Product Change Notice

Issue Date: 27-December-2022

Introduction of new die source

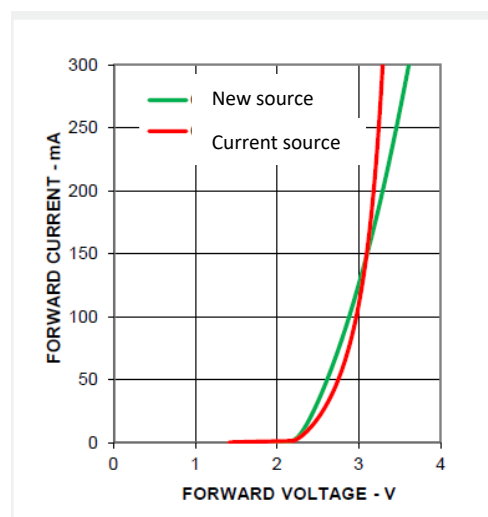
Only Vf characteristics of ASMT-QGBE-NGJ0E is slightly different compared to current die source as illustrated below.
